**E4419B-07A**

**S E R V I C E N O T E**

**Agilent E4419B EPM Power Meter**

**Premature RAM Backup Battery Failure**

**Figure 2. Location of Surface Mount Resistors**

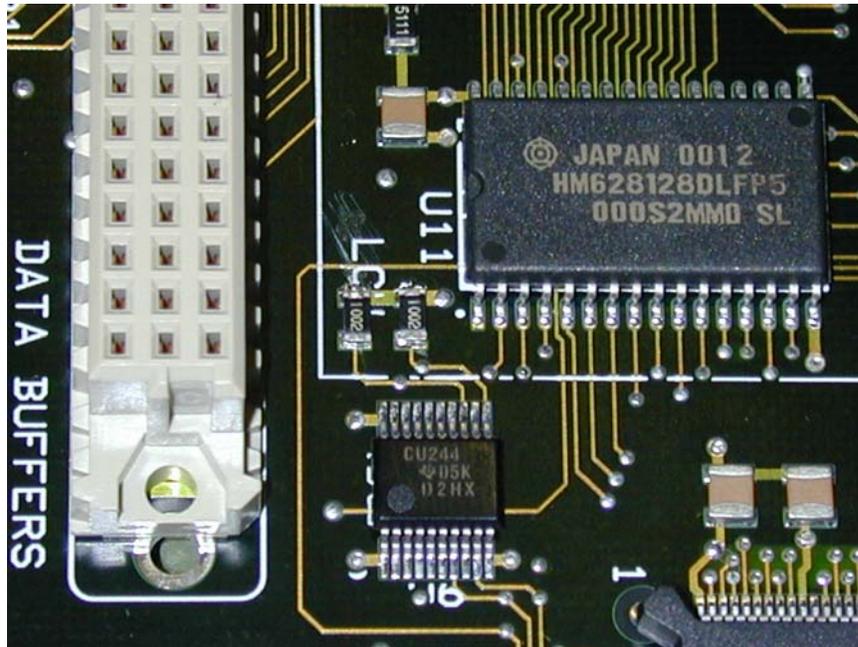
Two pull-up resistors were added as part of this design change. It has since been discovered that these pull-up resistors reduce the lifetime of the RAM lithium backup battery. The backup battery is needed to retain data in the memory when the unit is disconnected from the mains power supply. This will not affect measurement integrity of the unit, however the unit will lose all user data that was stored in it before the battery failure occurred. When the battery has failed it will display the following Power On Self Test error: RAM Battery Failed.

3. Processor Assembly revisions prior to 'S' are not covered by this service note. RAM backup battery failures on these boards may be detailed in a previous service note, or they may simply be caused by natural aging of the unit. Check other service notes for this unit to verify this failure mode is not likely to be caused by any other documented problems. Do not carry out steps 4 to 14.
4. Locate the two surface mount pull-up resistors (see Figure 2).

**Figure 3. Surface Mount Resistors Removed from Board**

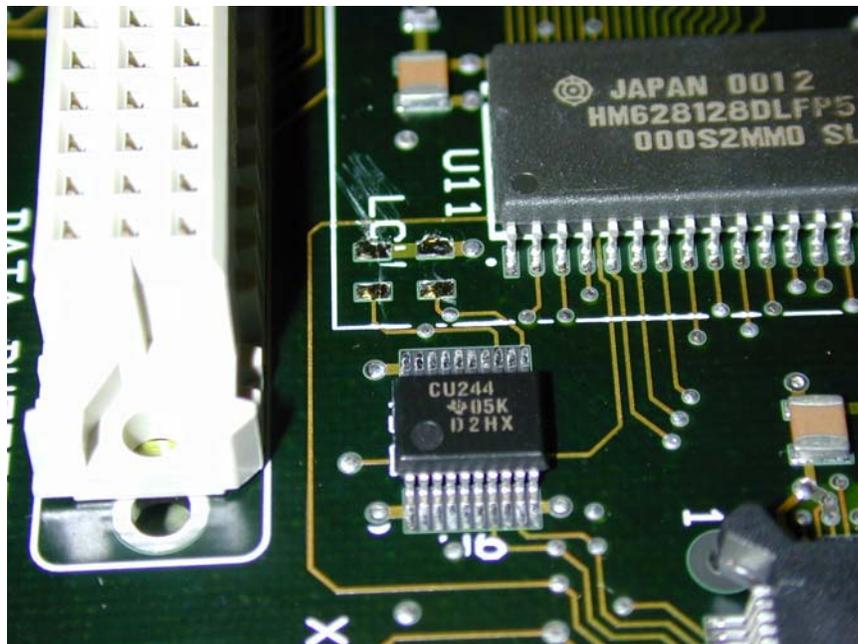
5. Remove the two surface mount pull-up resistors (see Figure 3).
